SUBJECT: PLANS AND PROPOSAL ADDENDUMS
PROJECT: STP 2023 (675)MM CONTROL: 1433-02-044
COUNTY: COMAL
LETTING: 05/04/2023
REFERENCE NO: 0419

PROPOSAL ADDENDUMS

DESCRIPTION OF ABOVE CHANGES
(INCLUDING PLANS SHEET CHANGES)

OVERHEAD UTILITIES:

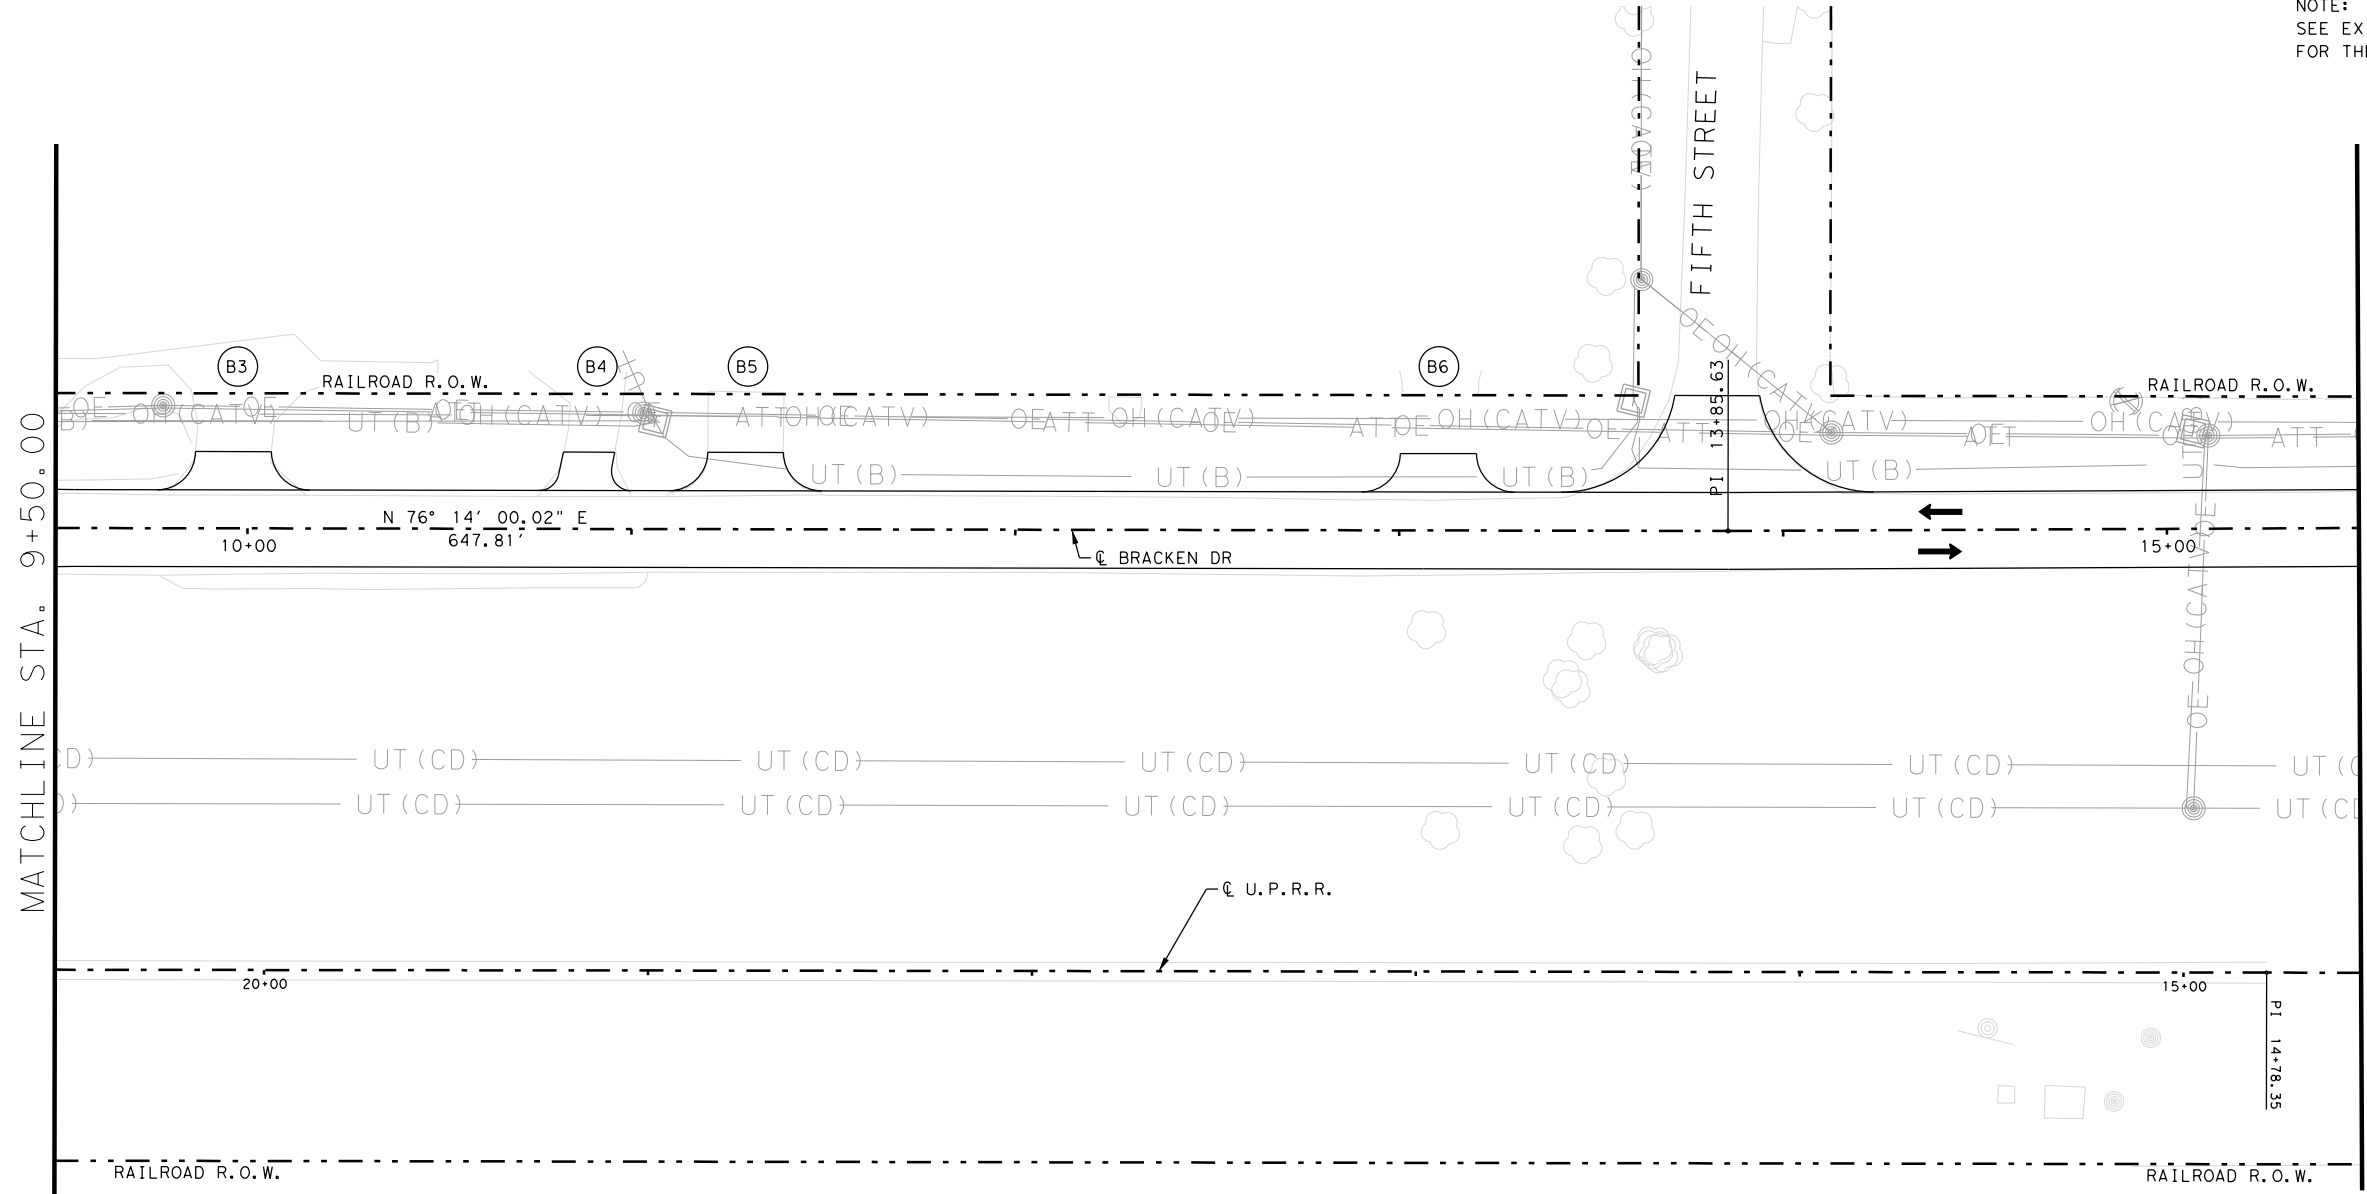
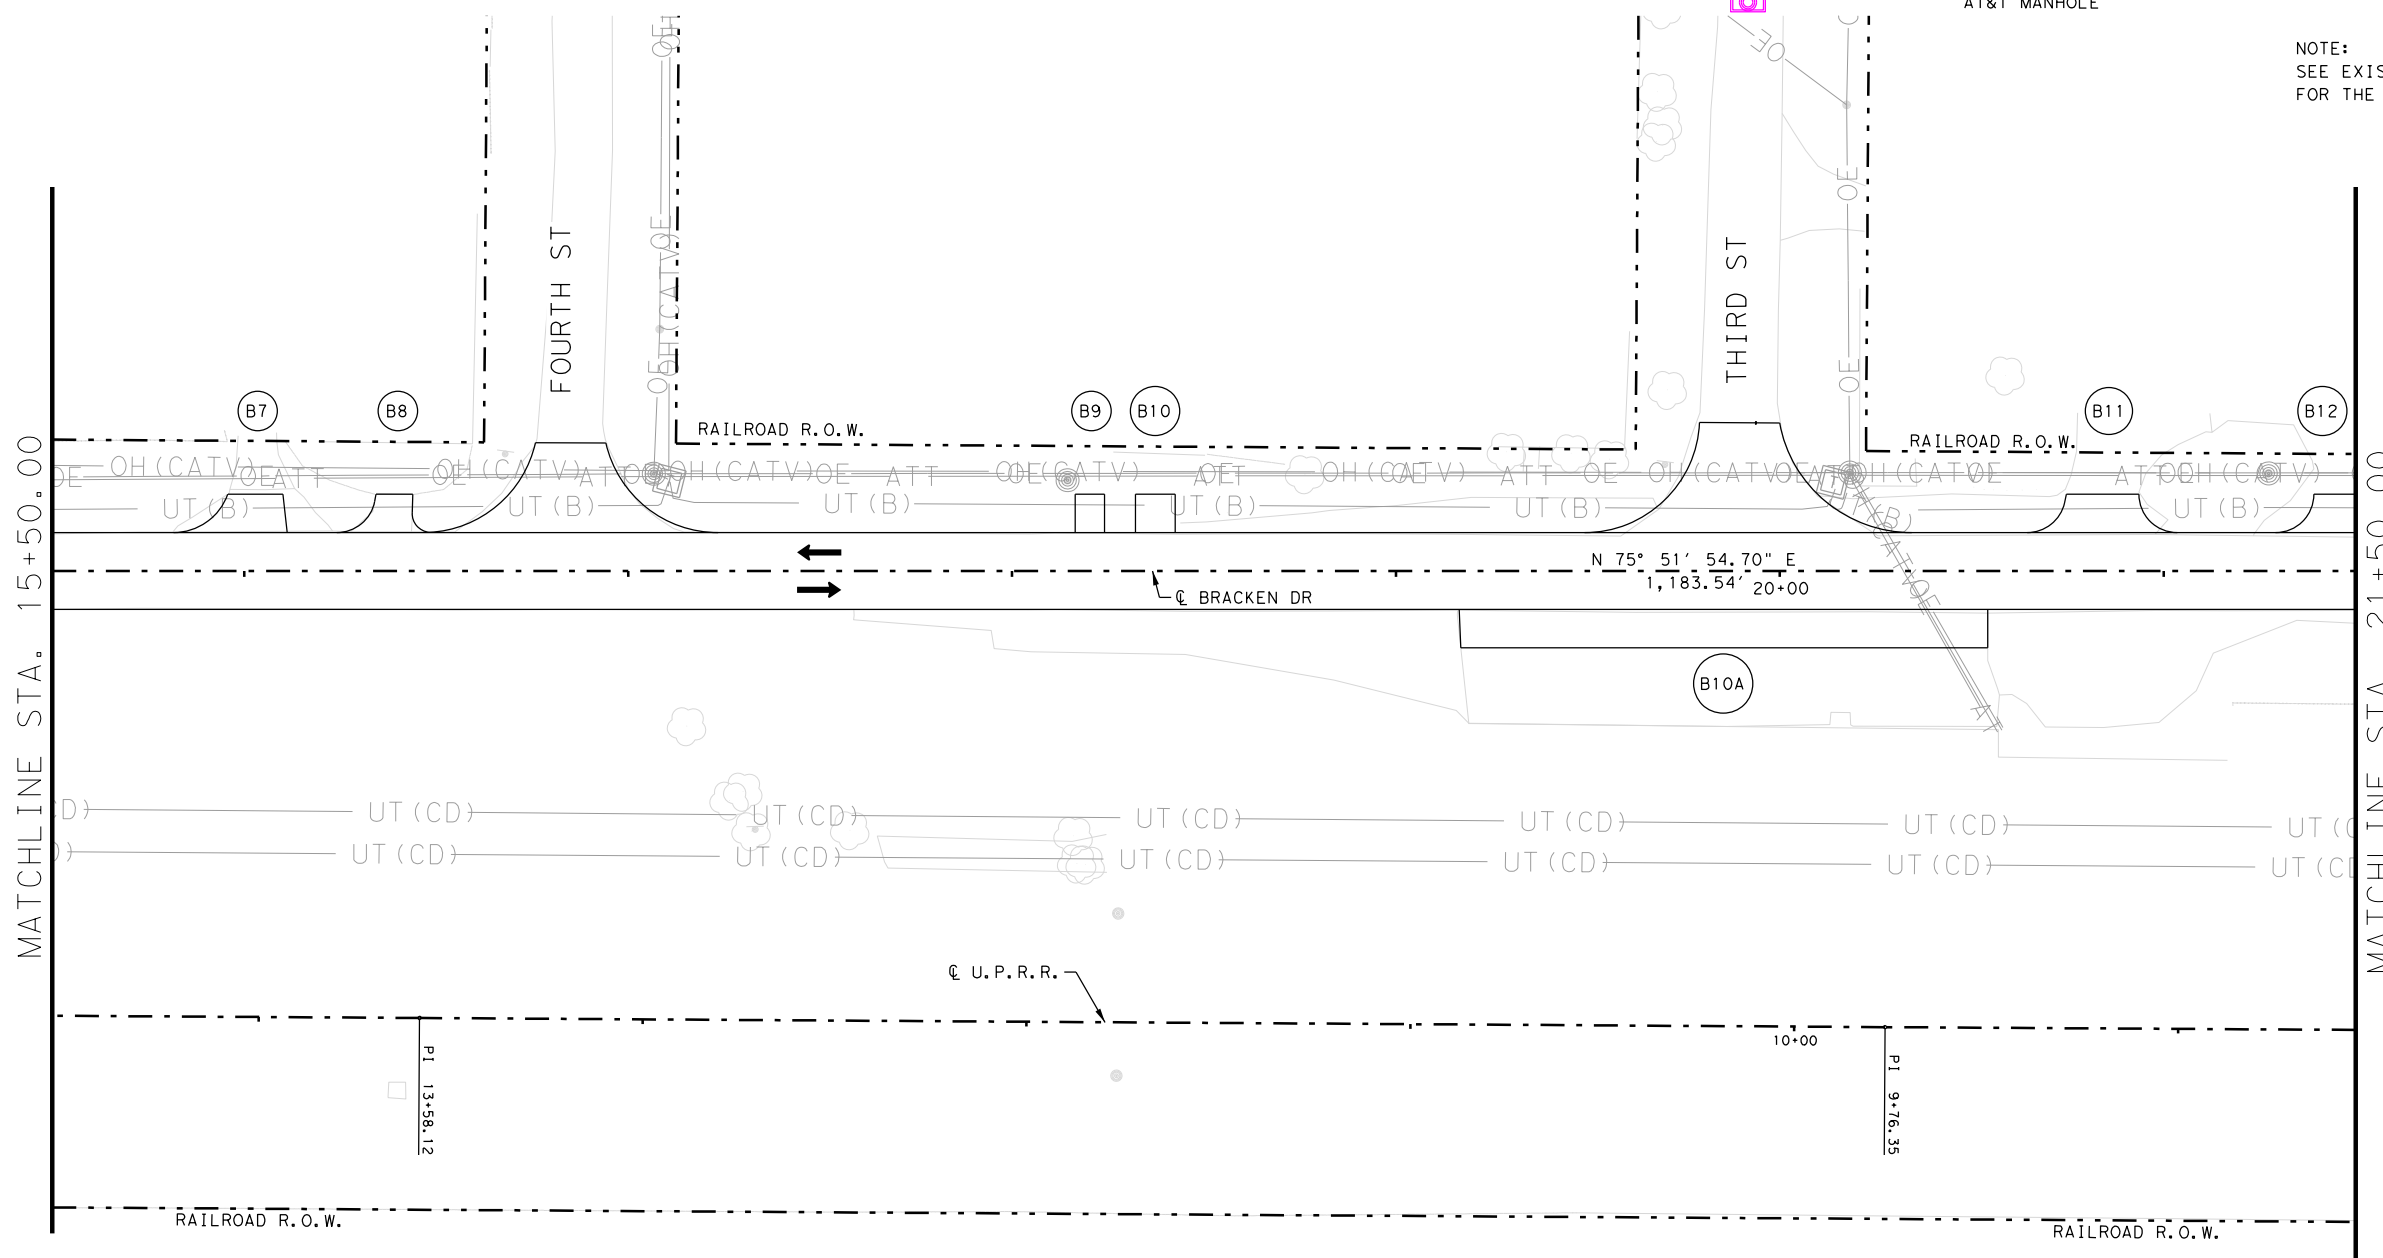
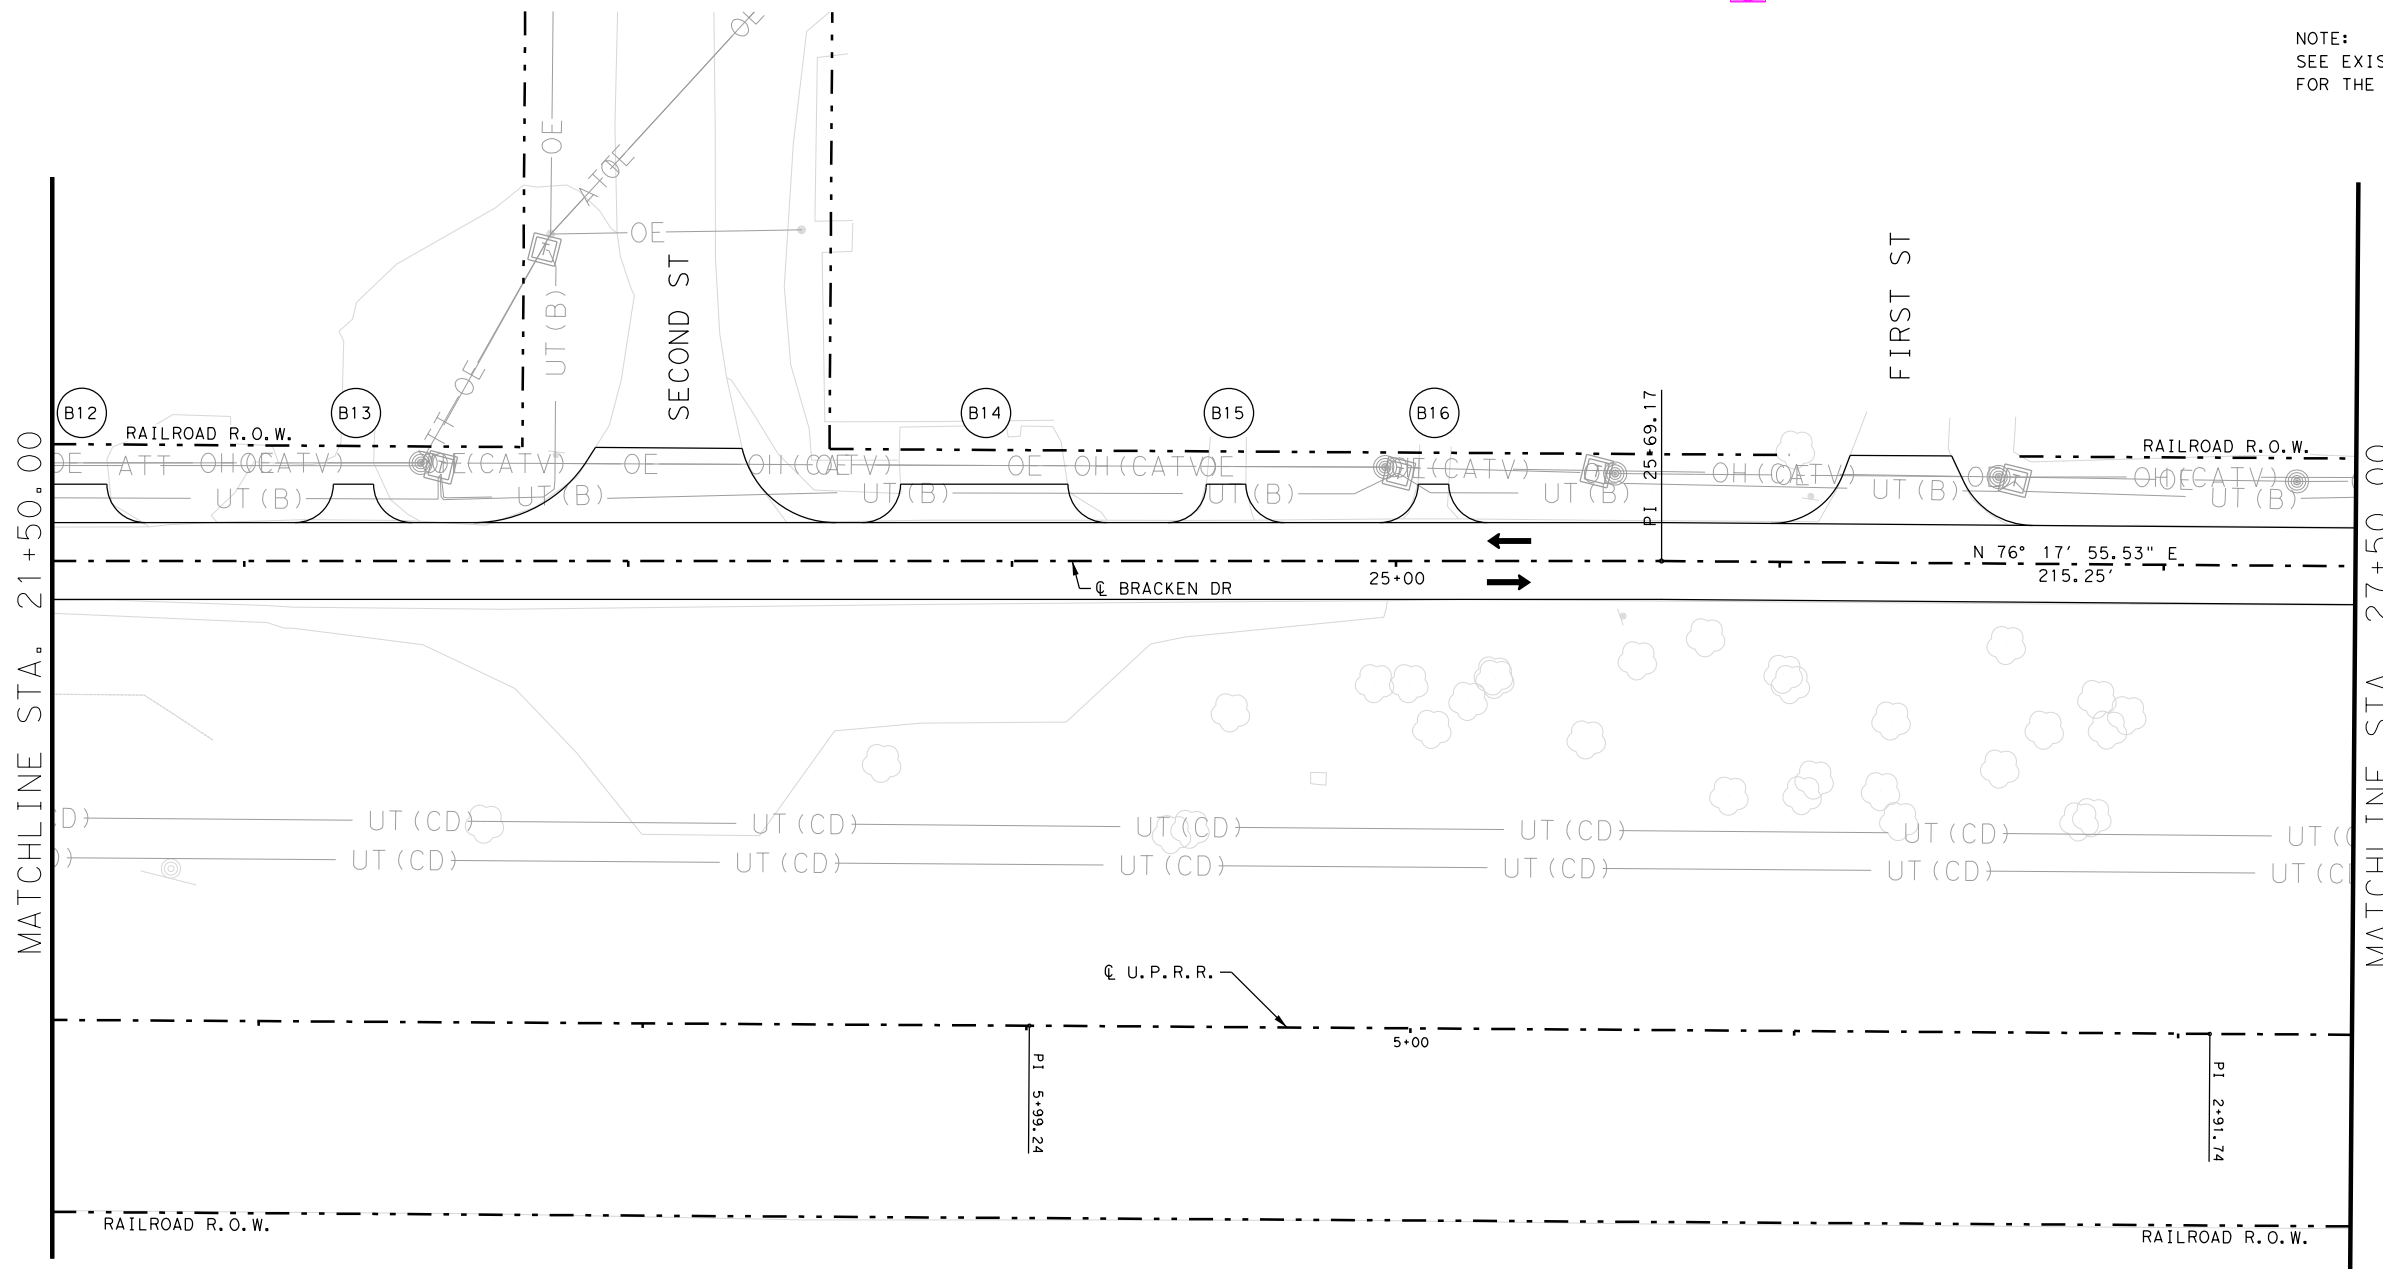
SHEETS 1330-1365: UPDATED UTILITY PLANS SHEETS LAYOUTS WITH CURRENT GAS
